AMENDMENTS TO THE DRAWINGS:

Inventor(s):aph Indhiran Vanniasinkam Application : 10/764,979
Title: OPTICAL ROSA FOR LONG REACH OPTICAL TRANSCEIVER

FIG. 1

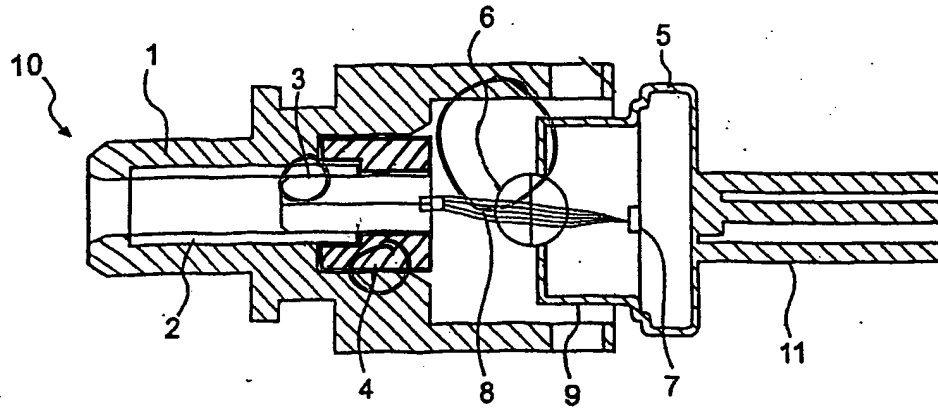
Applicants amend Fig. 1 to be more consistent with the other Figures. In particular, Applicants amend Fig. 1 to properly include the stub holder 4 as shown in Fig. 2 and described in the specification at page 6, paragraph 19 and page 7, paragraph 21. Further, Applicants amend Fig. 1 to properly indicate that lens system 6 should point to the circular lens as shown in Figs 2 and 5B. Furthermore, Applicants amend Fig. 1 to clarify that item 3 points to the fiber stub and not the core of the fiber stub, which is consistent with Figs. 3 and 5A.
